# Administrative Approval Action

Case File / Name: ASR-0008-2020  
City Barbecue Lake Boone Trail

**REQUEST:** Development of a 1.61 acre/69,696 sf tract zone CX-5-PL-CU & CX-5-CU consisting of existing Lots 3 and 4, recorded in BM 2015 PG 2011. Lot 3 (.87 acres) is a proposed Open Lot and will remain vacant with no development with exception of 2 proposed cross-access drives. Existing Lot 4 will be developed into a proposed 4,000 sf restaurant building with a 650 sf patio area with 37 provided parking spaces.

**FINDINGS:** City Administration finds that this request, with the below conditions of approval being met, conforms to the Unified Development Ordinance. This approval is based on a preliminary plan dated July 13, 2020 by McAdams.

**SITE PLAN**

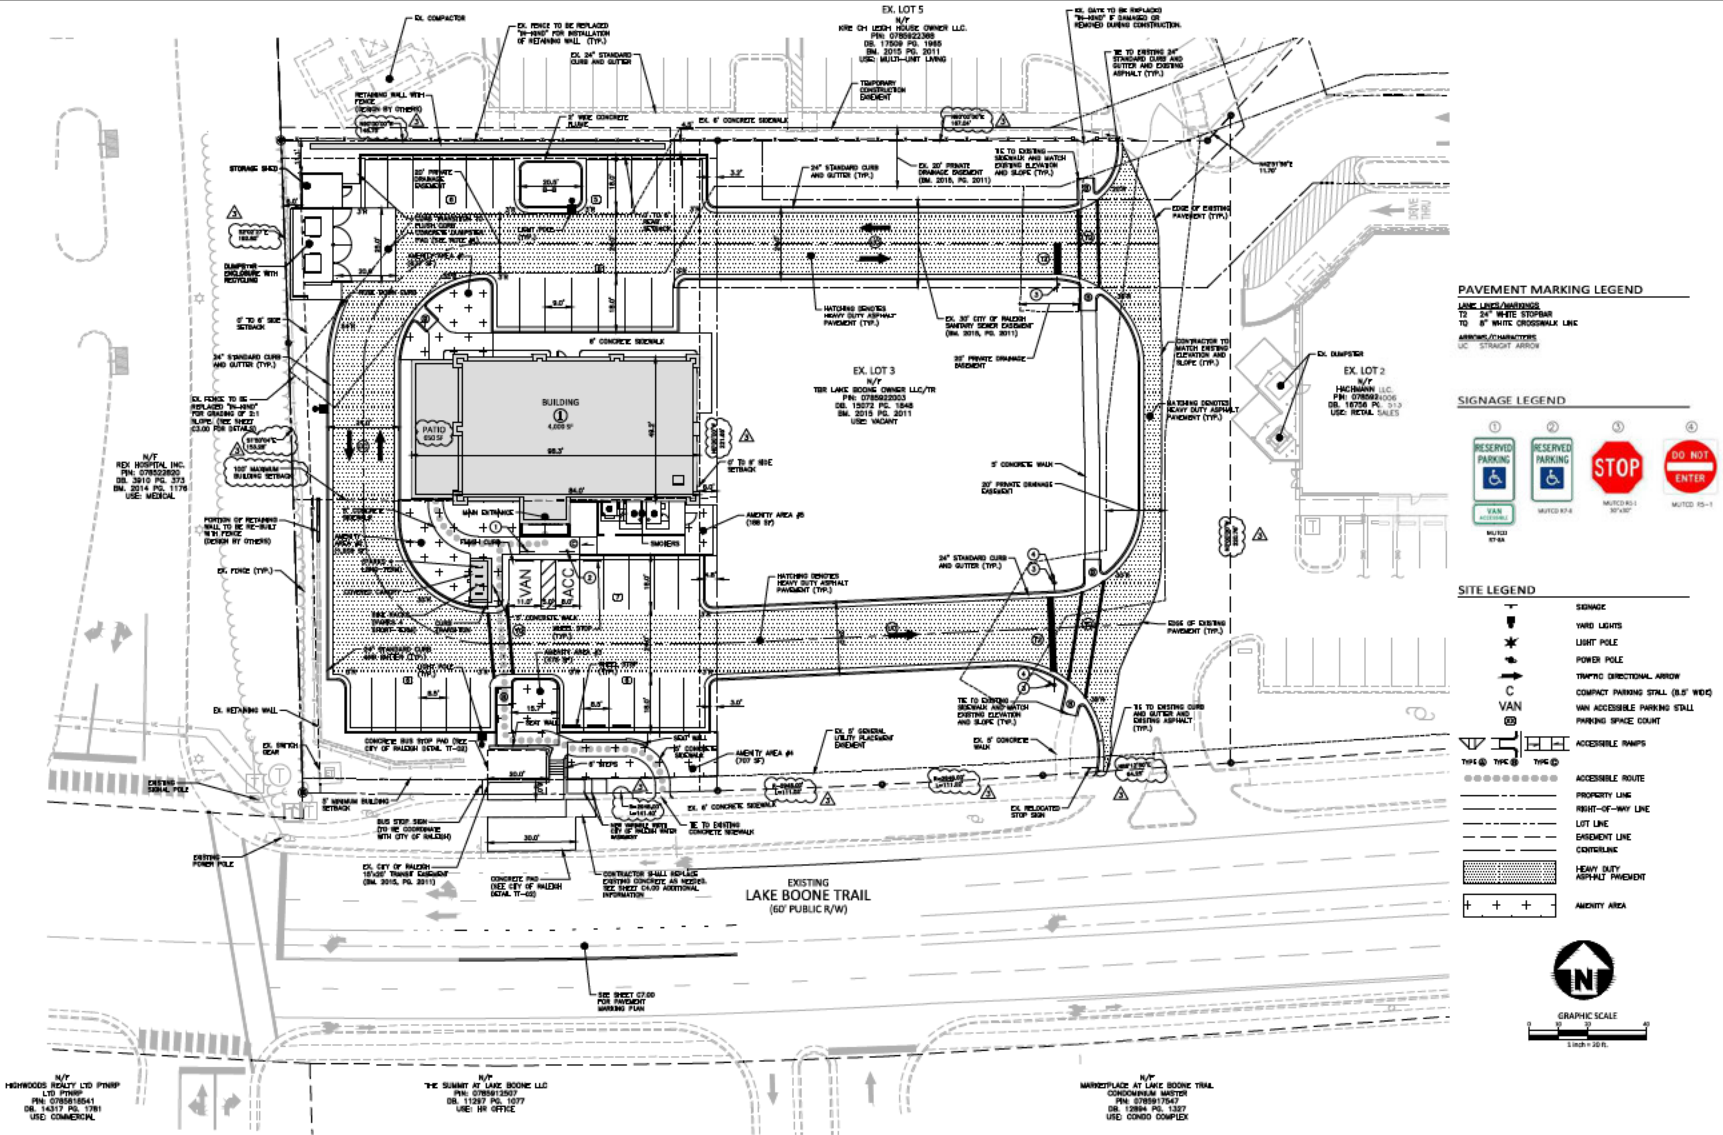
1. That the arrow direction the use of the turn lane into the site is removed from the pavement as shown on the site plan and the Signing and Marking Manager in Transportation Operations RDOT approves the removal.
2. That a City of Raleigh standard concrete pad for the relocated Transit stop is constructed per the Plans and inspected by the Transit Division of RDOT.

**LANDSCAPE PLAN**

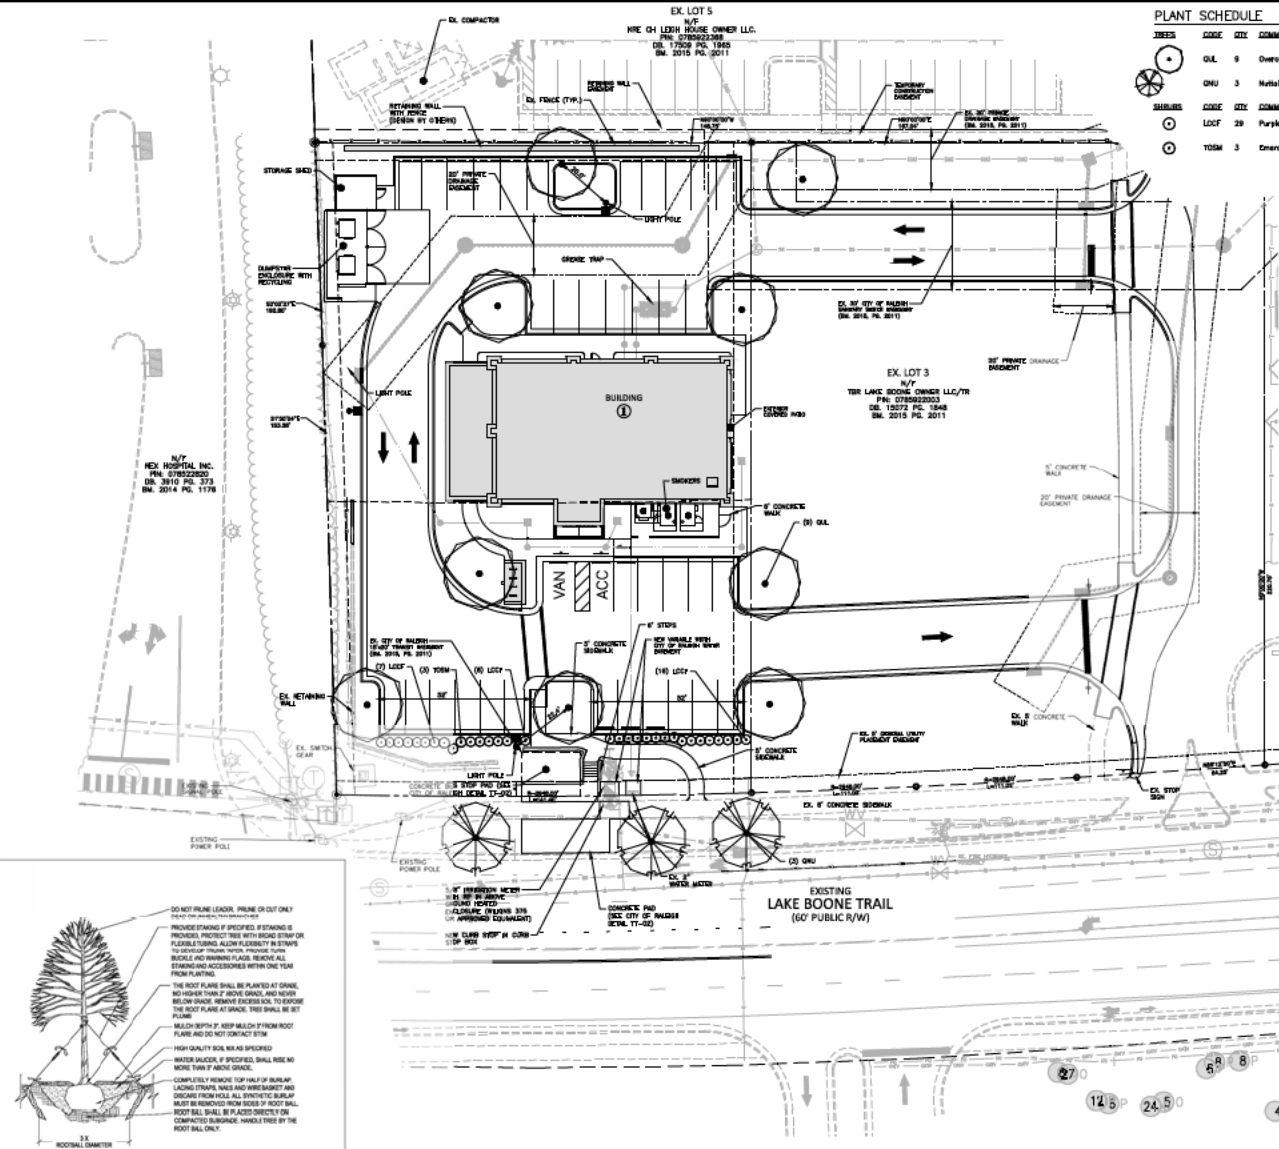
5. A tree impact permit must be obtained for the approved streetscape tree installation in the right of way. This development proposes 3 street trees along Lake Boone Trail.
6. A public infrastructure surety for 3 street trees shall be provided to the City of Raleigh Development Services – Development Engineering (UDO 8.1.3).
